UNITED STATES PATENT AND TRADEMARK OFFICE

APPLICATION NO.	FILING DATE	FIRST NAMED INVENTOR	ATTORNEY DOCKET NO.	CONFIRMATION NO.
10/764,977	01/26/2004	Curt D. Seymour	70026970-0011	9301
26263	7590	10/19/2005		
SONNENSCHN NATH & ROSENTHAL LLP P.O. BOX 061080 WACKER DRIVE STATION, SEARS TOWER CHICAGO, IL 60606-1080			EXAMINER ROYAL, PAUL	
			ART UNIT	PAPER NUMBER
			3611

Office Action Summary

DETAILED ACTION

FIG. 2

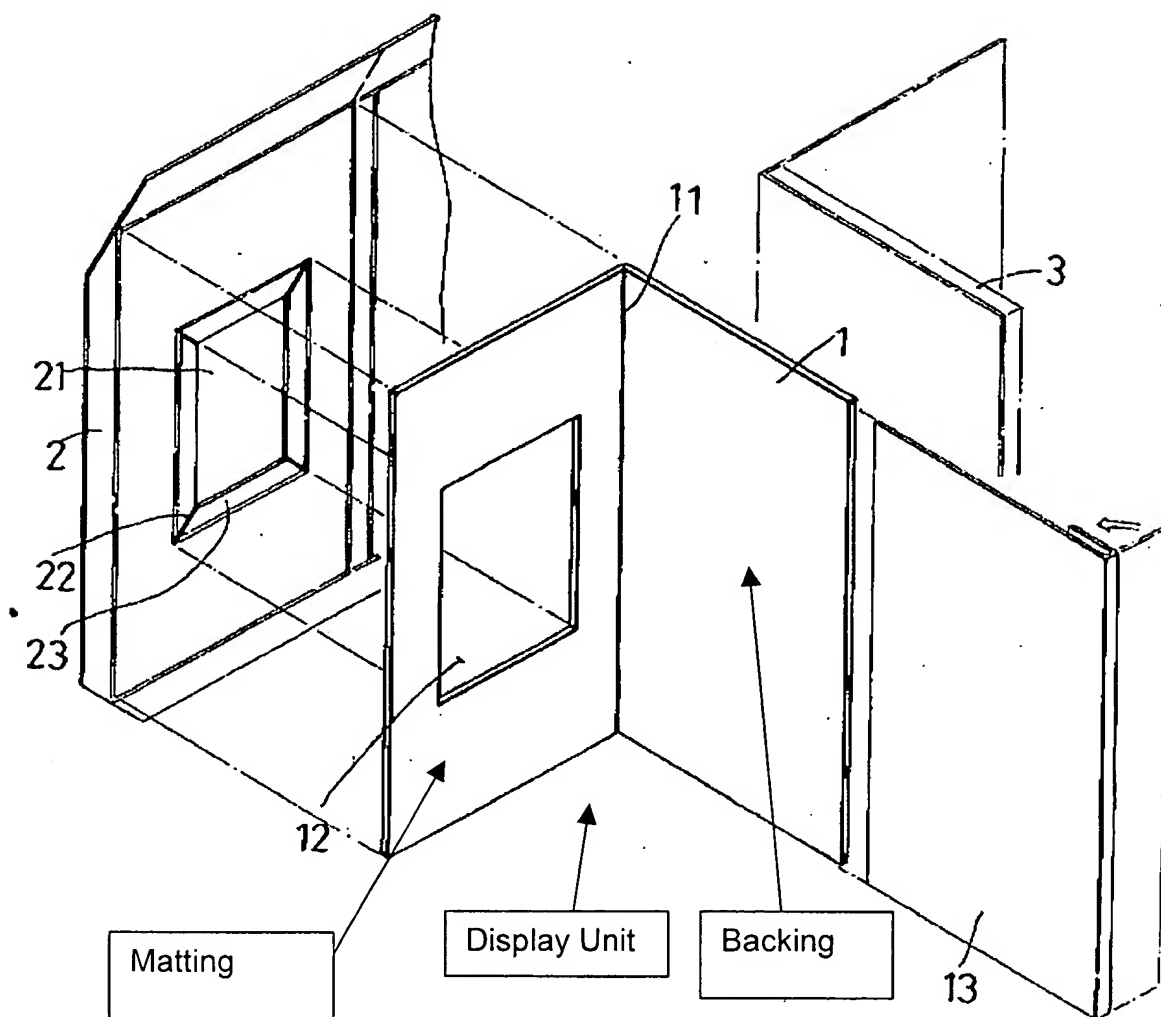
Tsai teaches a front cover mountable with a photograph for books having a display unit (Display Unit, see Examiner's annotated Figure 2) having a hinged (11) backing (Backing, see Examiner's annotated Figure 2) and matting (Matting, see Examiner's annotated Figure 2) including a cut out (12) corresponding to a cover opening (21) of the book cover (2) and the alignment of the alignment of cut-out and opening, to provide a front-cover mountable with a photo to give a book a unique impression.

It would have been obvious to one having ordinary skill in the art at the time the invention was made to modify the custom display and storage system of Stanley to include having a display unit including a hinged backing and having matting including a cut out which corresponds to a cover opening of a book cover and the alignment of the alignment of cut-out and opening, to provide a front-cover mountable with a photo to give a book a unique impression.
